MANATEE COUNTY FLORIDA

SUBJECT: Invitation for Bid #09-2574DC
Fleet Services Building Addition Phase 2
ADDENDUM #3

STRUCTURAL RENOVATION
 FOR
MANATEE COUNTY FLEET SERVICES
 LOCATED AT
 1100 28TH AV. EAST, BRADENTON, FLORIDA

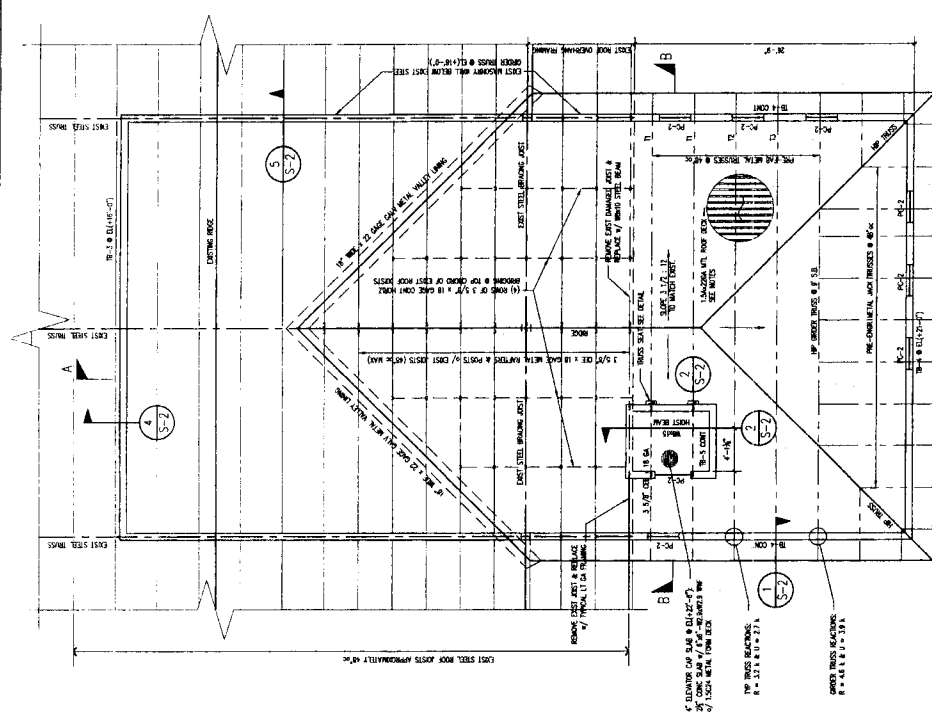
Question #5: Yesterday I stopped by and did a visual inspection of the Job site for the Fleet Building Addition on 26th Ave E. Upon looking at the additional space you're trying to renovate, you may wish to consider a vertical incline lift, WOV. It requires a 6" or less pit and has up to 1000# capacity which should handle personnel or moving material. Requires minimal shaft construction cost. It would be much more cost effective and I believe it would serve your purpose for that particular location. And a LULA (Limited Use Limited Access) Elevator requires only a 24" pit and single phase power supply reducing your construction costs

Response #5: Thank you for the proposed alternate elevator design, however please bid the elevator as designed.
